**Cardinia Planning Scheme Amendment C257card  
Woodland Grove Precinct**

**Panel Report**

**29 July 2021**

Figure 3 Exhibited Clause 6.0 Figure 1

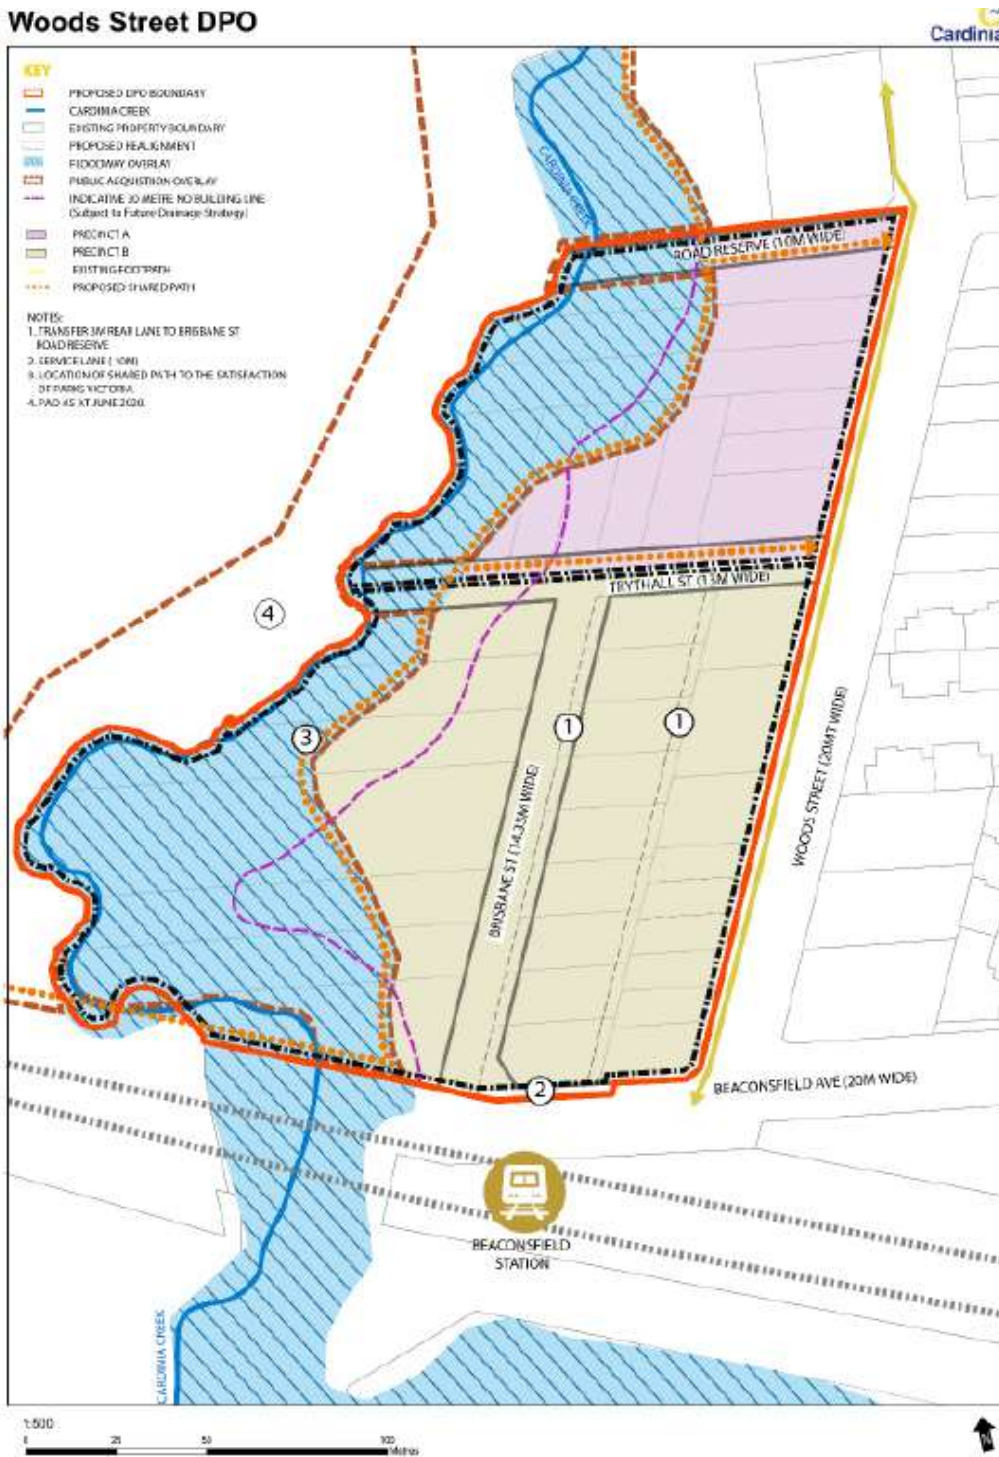
Mr Smith requested that the position of Brisbane Street be altered to provide sufficient space between the road and the 30 metre creek setback to enable the development of some lots. He added that alternative access arrangements from Beaconsfield Avenue to Brisbane Street should also be considered. He recommended that the title of Figure 1 be changed to 'Indicative Concept Plan: Woodland Grove Precinct'. Mr Smith also requested that the location of the rail corridor be clarified in Figure 1.

Council added: Figure 1 is a 'concept plan' and should be viewed as indicative. If an appropriate design is put to Council an alternative layout will be considered providing the requirements of the development plan listed at Clause 4.0 of the DPO25 schedule are satisfied.

In response to Mr Leonard's submission, Council proposed altering Figure 1 as discussed above and the addition of Figure 2 to provide further clarity.

The Panel notes that the reference to Figure 1 and proposed Figure 2 occurs only in the Traffic and Transport requirements of Clause 4.0 and requires the roads to be generally in accordance with them or an alternative layout to Council's satisfaction. In the Panel's view this provision provides the flexibility sought by Mr Smith with regard to the position of Brisbane Street and the potential for different access from Beaconsfield Avenue to Brisbane Street.

- The inclusion of Figure 2 is appropriate.

- The rail corridor should be clearly marked on both Figures.
- Figure 1 should be renamed to 'Indicative Traffic and Transport Plan Woodland Grove Precinct'.

- a) clearly identify the rail corridor in Figures 1 and 2**
- b) rename Figure 1 to 'Indicative Traffic and Transport Plan Woodland Grove Precinct'.**
